REVISED RESPONSE TO REQUEST FOR ADDITIONAL INFORMATION

APR1400 Design Certification

RAI No.: 13-7856

SRP Section: 12.02- Radiation Sources

Figure 1. Shielding and Layout of Holdup Tank

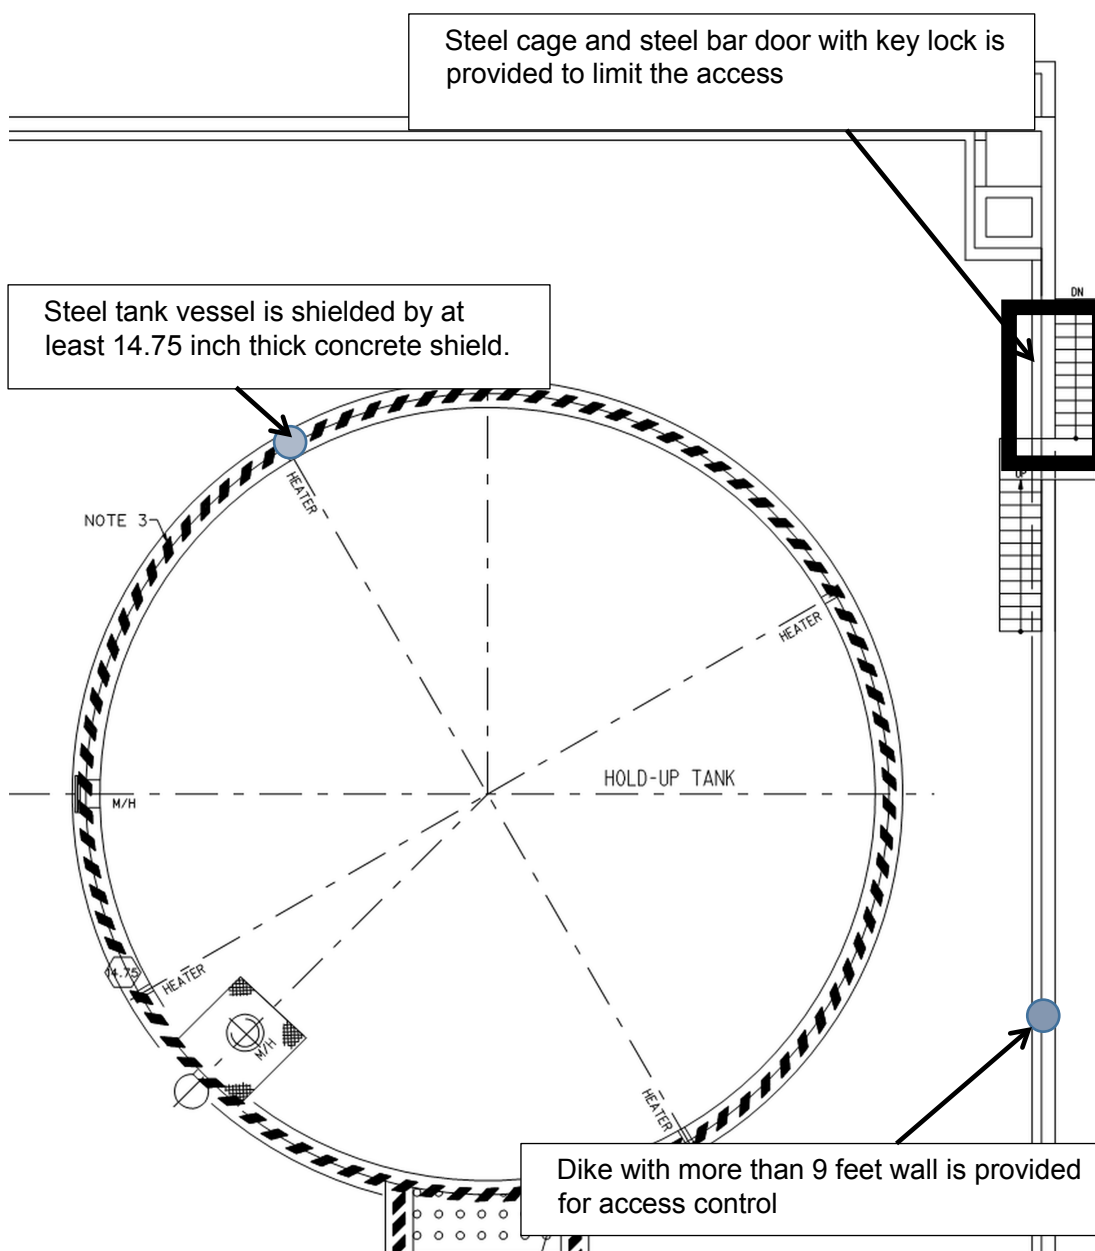
- b. Please indicate if there will be any shielding or barriers surrounding the tanks to limit doses to workers and members of the public and update the FSAR accordingly.

- b. As presented in Figure 1, the holdup tank itself is composed of a steel vessel with a minimum 14.75-inch thick concrete shield wall outside the vessel to ensure that the dose rate outside the tank is less than 2.5 $\mu\text{Sv/hr}$. This design feature is also applicable to the BAST. The RWMT is not shielded with concrete since the design basis dose rate outside the vessel is low enough to maintain the dose rate below 2.5 $\mu\text{Sv/hr}$ without the concrete shield wall.
